DECLARATION OF IDENTITY

- Manufacturer : LG Electronics Inc.
- Applicant : 219-24, MC R&D A, Gasan-dong, Gumcheon-gu, Seoul, 153-801, KOREA
- Type of Product : Bluetooth Headset
- FCC ID (Model Name) : BEJHBS730 (HBS-730)
- Certification date : 2012. 07. 06

We hereby declare that changed model is mechanically and technically identical to original model except as below,

Changing Information

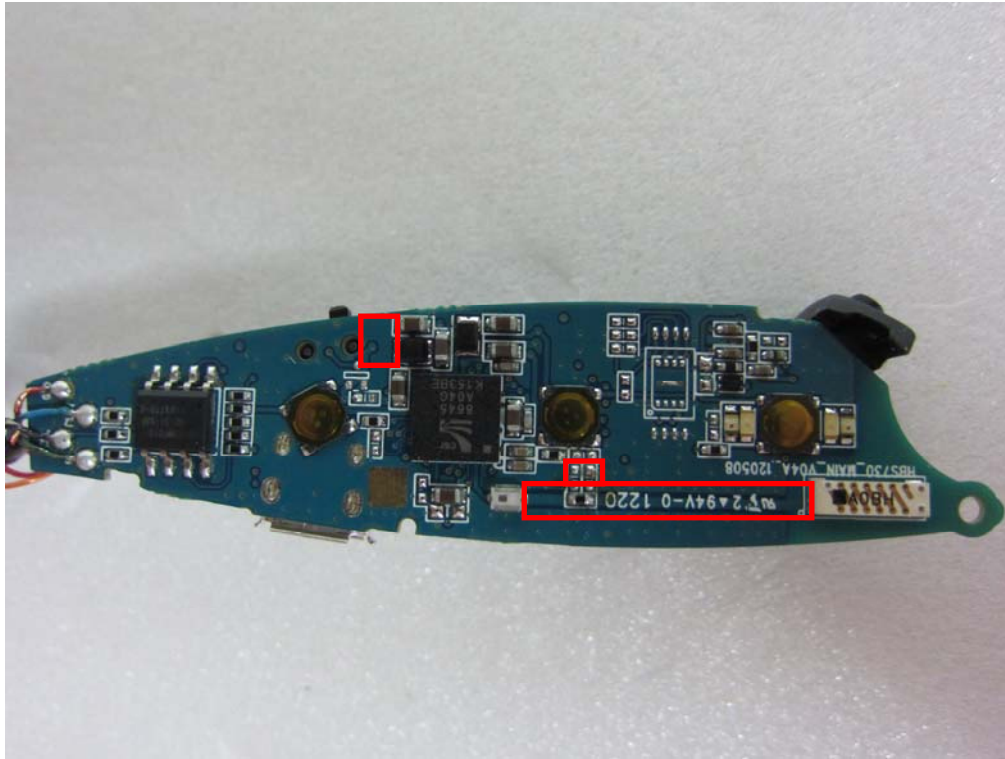
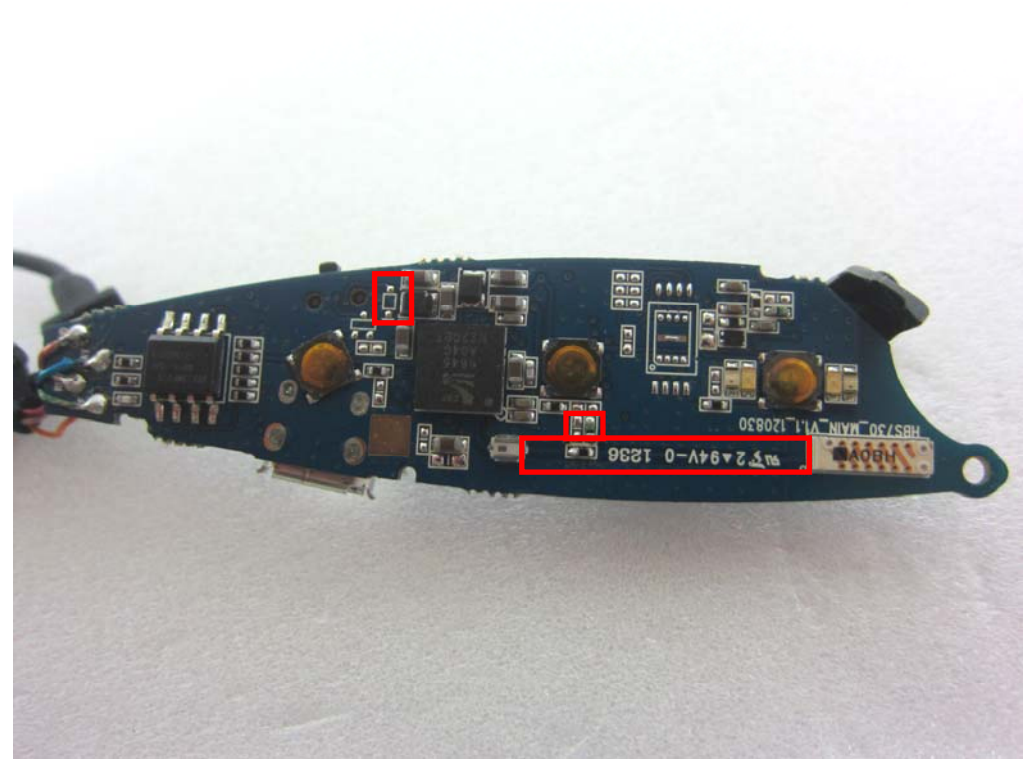
1. Addition: D1(NC)
2. Pattern Change
3. Value change: L5, C33

Changing Information

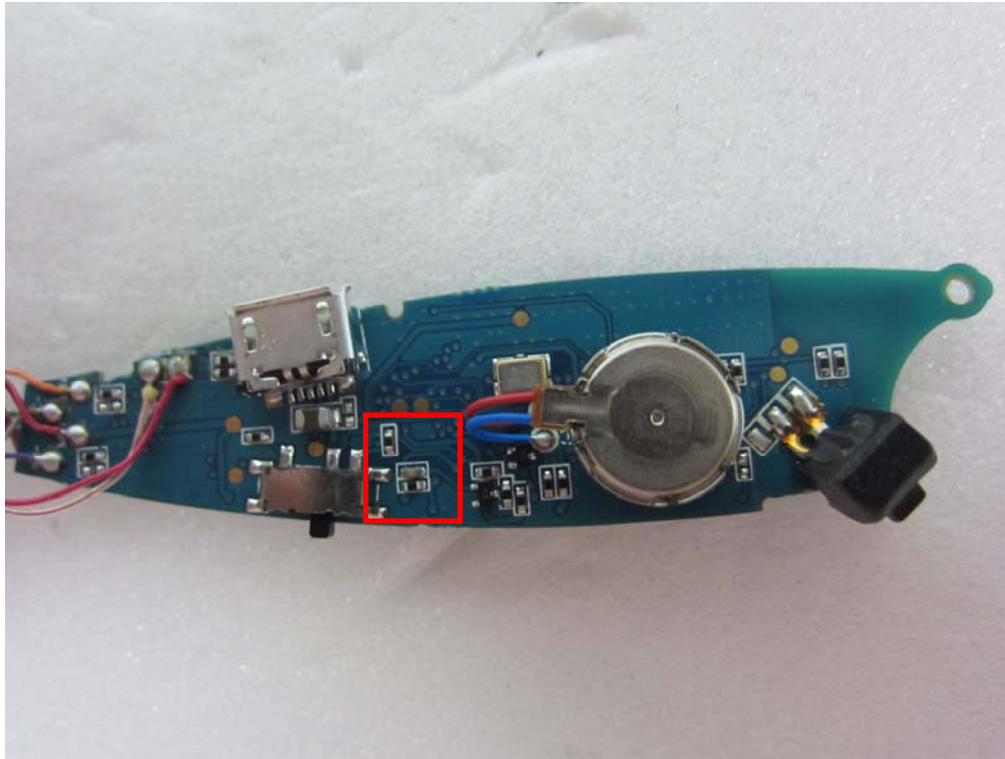
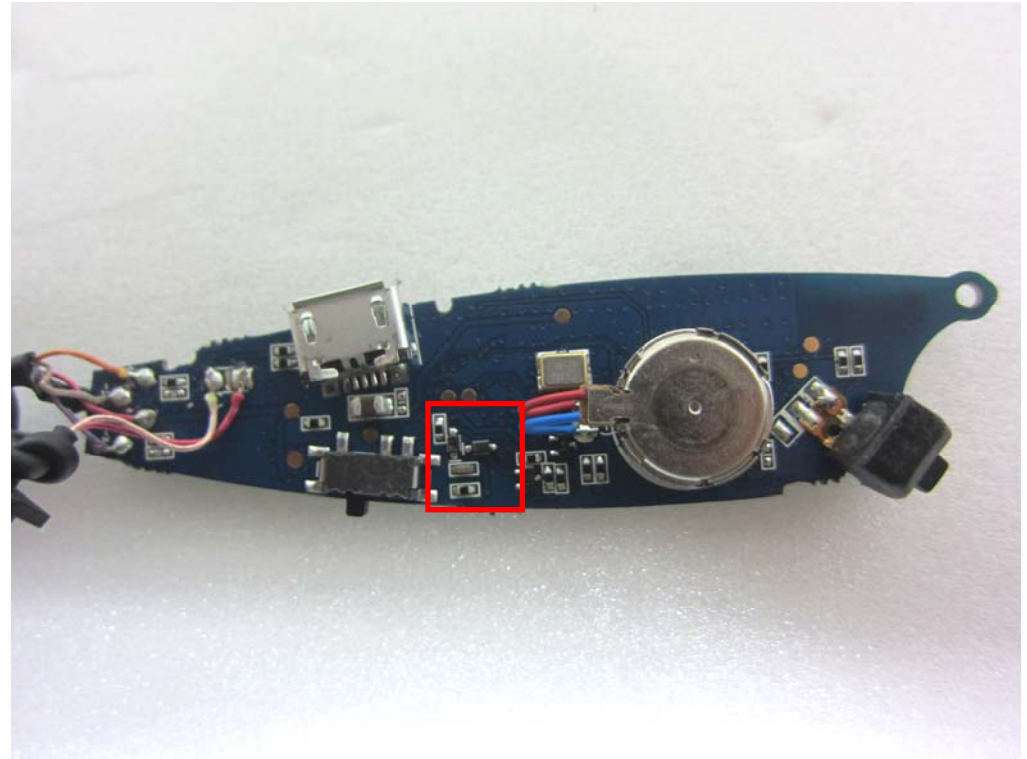
1. Location change: R11, C3
2. Addition: D2(WSD520S), D3(WSD520S)
